February 13, 2026

Southeast Behavioral Health Clinic Toilet Room Remodel
Fargo, ND

ADDENDUM NO. 01

A106

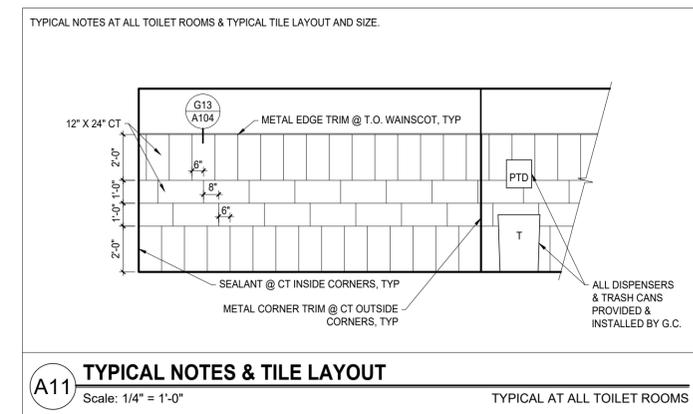
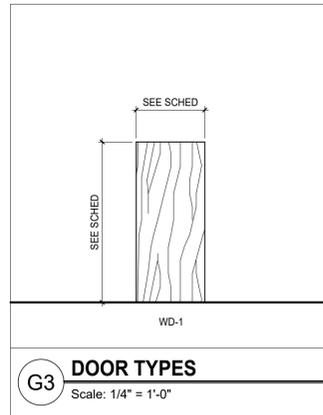
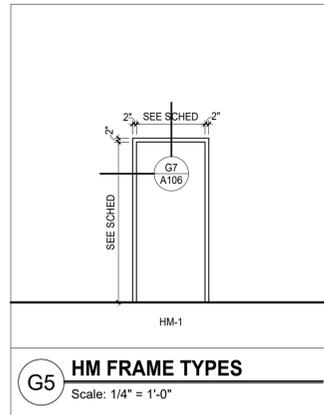
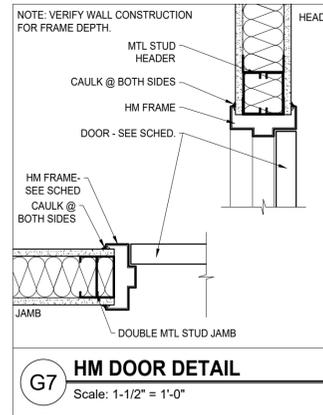
- A. Reference Door Hardware Schedule: Revise door hardware for doors 110B and 110B ALT as shown in attached Drawing.

Drawing Title: **MAIN LEVEL - POWER AND SYSTEMS PLAN**

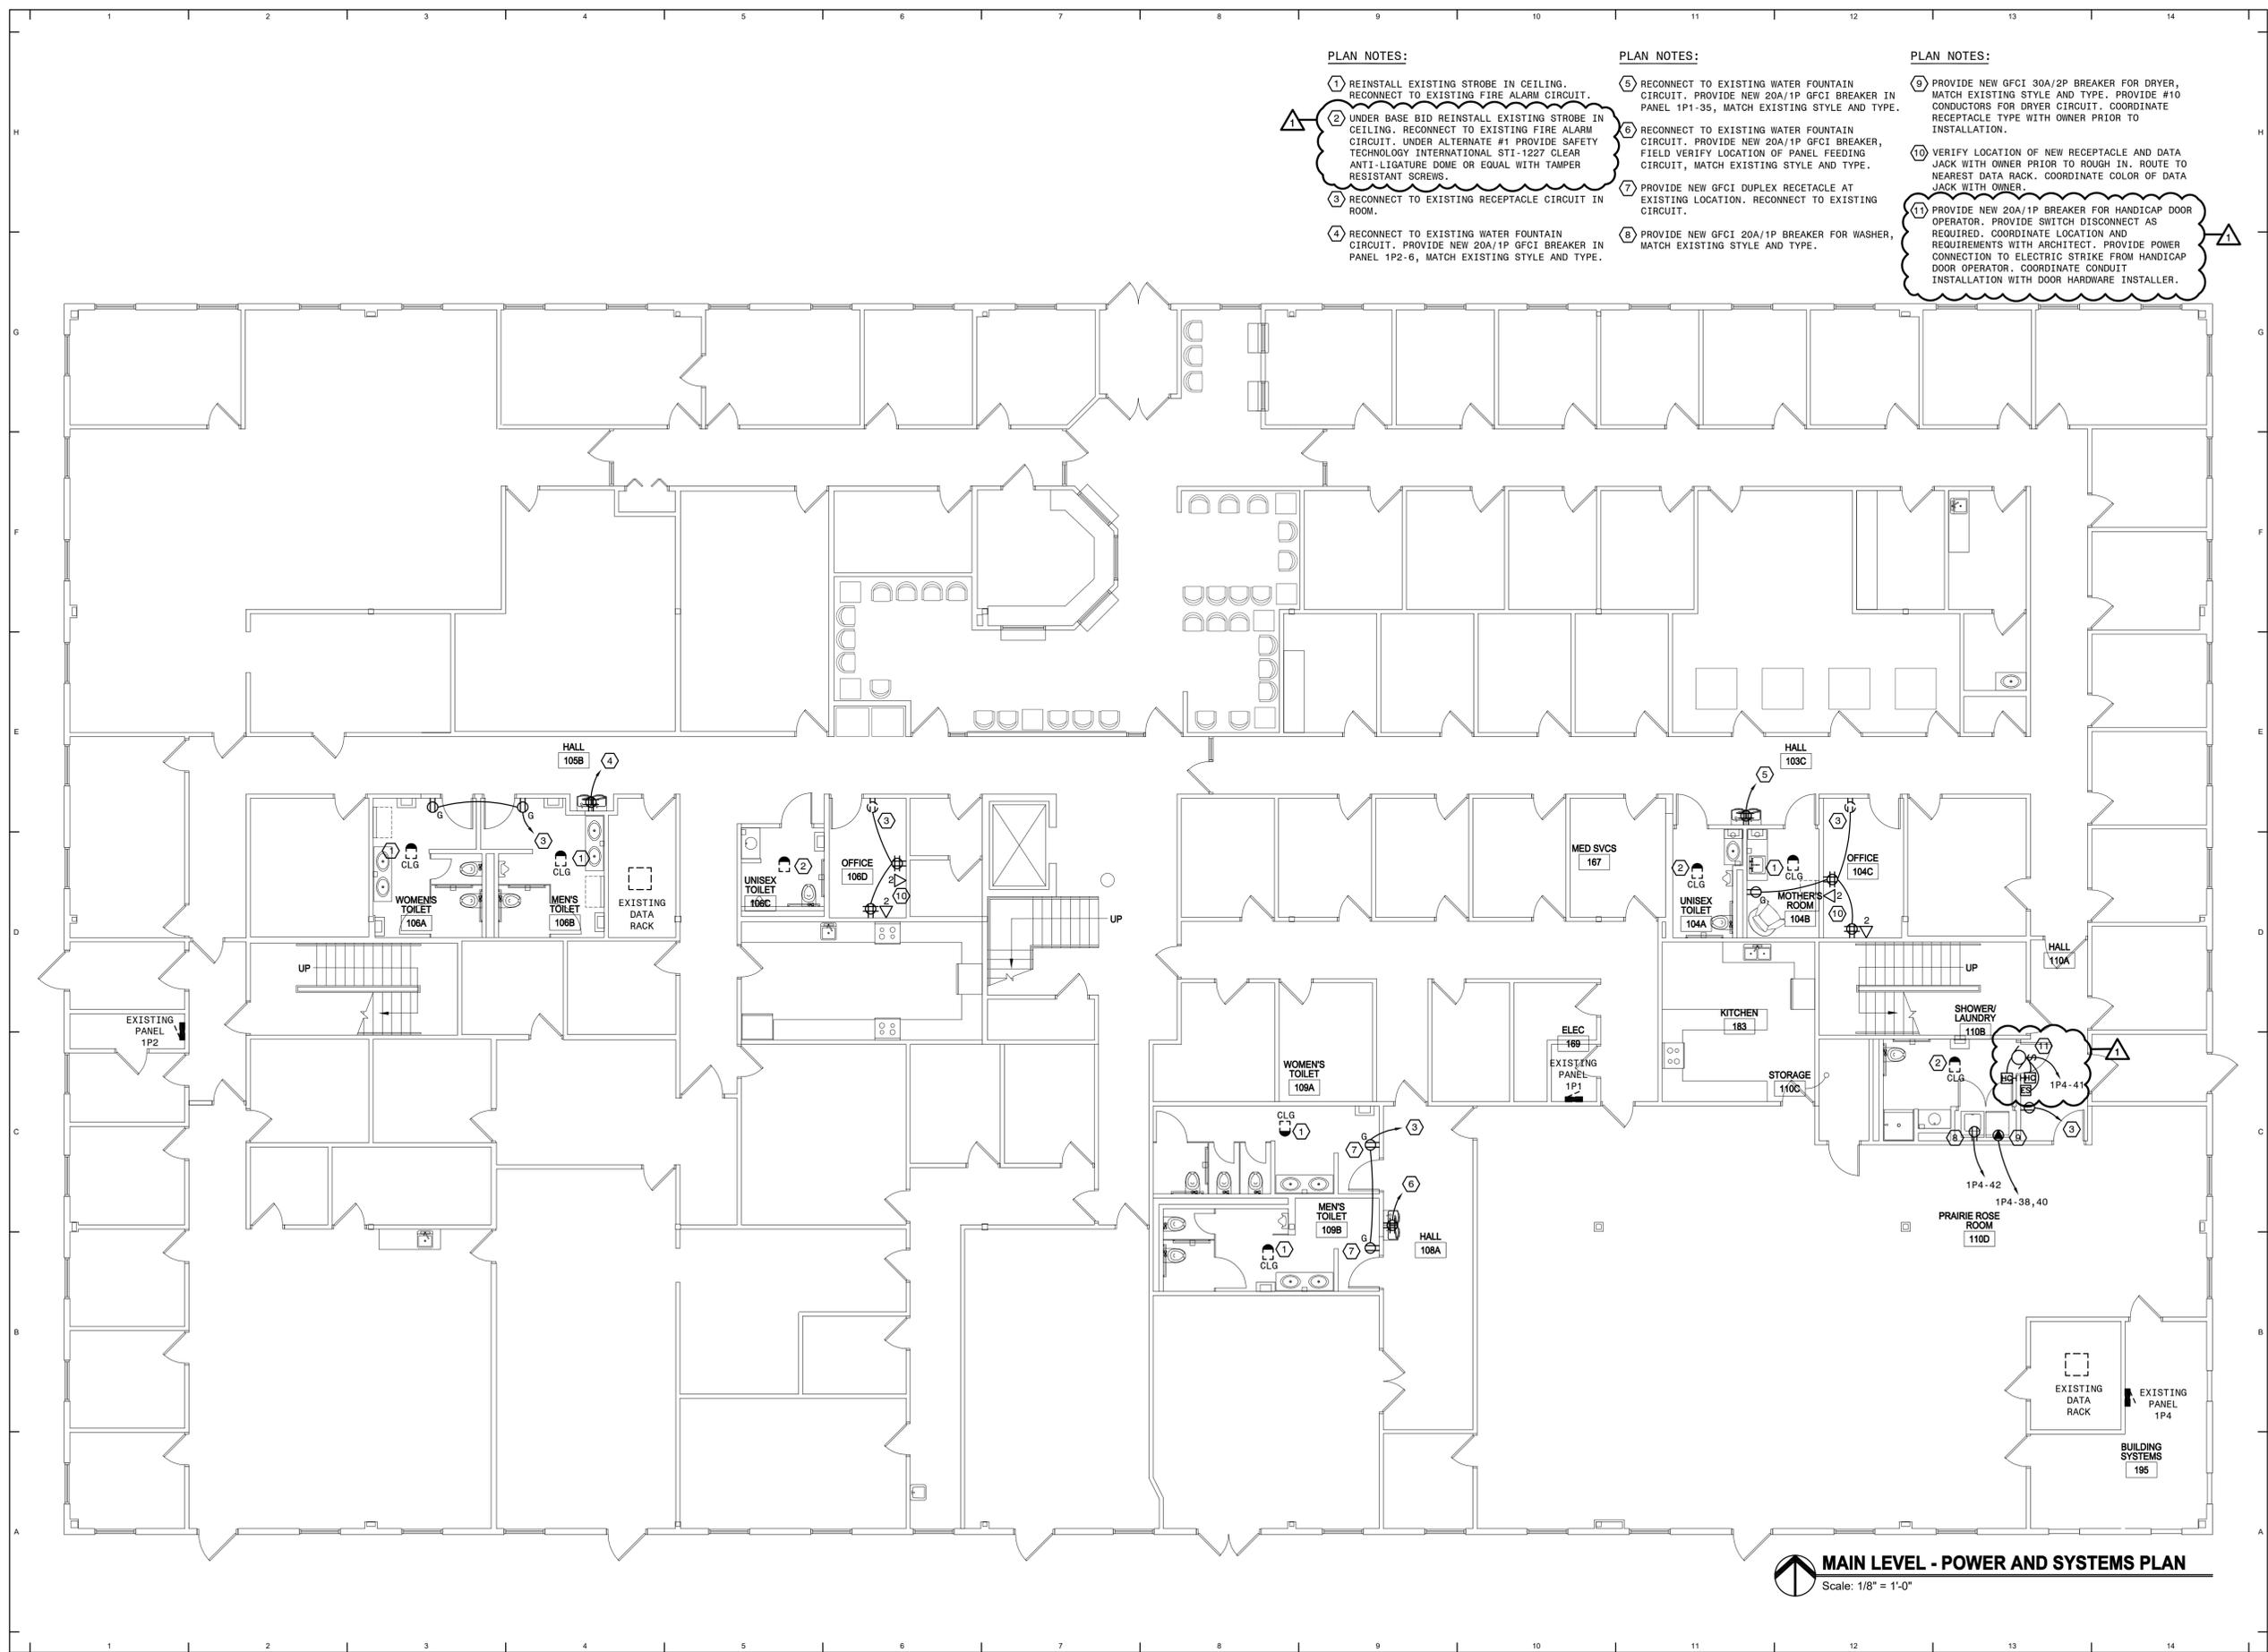
- A. Reference Plan Notes: Revise Note #2 per the attached Drawing.
- B. Reference Plan Notes & Main Level – Power and Systems Plan: Revise note #11 per the attached Drawing. Add power connection to electric strike in Shower/Laundry 110B.

- 1 REINSTALL EXISTING STROBE IN CEILING. RECONNECT TO EXISTING FIRE ALARM CIRCUIT.
- 2 UNDER BASE BID REINSTALL EXISTING STROBE IN CEILING. RECONNECT TO EXISTING FIRE ALARM CIRCUIT. UNDER ALTERNATE #1 PROVIDE SAFETY TECHNOLOGY INTERNATIONAL STI-1227 CLEAR ANTI-LIGATURE DOME OR EQUAL WITH TAMPER RESISTANT SCREWS.
- 3 RECONNECT TO EXISTING RECEPTACLE CIRCUIT IN ROOM.
- 4 RECONNECT TO EXISTING WATER FOUNTAIN CIRCUIT. PROVIDE NEW 20A/1P GFCI BREAKER IN PANEL 1P2-6, MATCH EXISTING STYLE AND TYPE.

- 9 PROVIDE NEW GFCI 30A/2P BREAKER FOR DRYER, MATCH EXISTING STYLE AND TYPE. PROVIDE #10 CONDUCTORS FOR DRYER CIRCUIT. COORDINATE RECEPTACLE TYPE WITH OWNER PRIOR TO INSTALLATION.
- 10 VERIFY LOCATION OF NEW RECEPTACLE AND DATA JACK WITH OWNER PRIOR TO ROUGH IN. ROUTE TO NEAREST DATA RACK. COORDINATE COLOR OF DATA JACK WITH OWNER.
- 11 PROVIDE NEW 20A/1P BREAKER FOR HANDICAP DOOR OPERATOR. PROVIDE SWITCH DISCONNECT AS REQUIRED. COORDINATE LOCATION AND REQUIREMENTS WITH ARCHITECT. PROVIDE POWER CONNECTION TO ELECTRIC STRIKE FROM HANDICAP DOOR OPERATOR. COORDINATE CONDUIT INSTALLATION WITH DOOR HARDWARE INSTALLER.
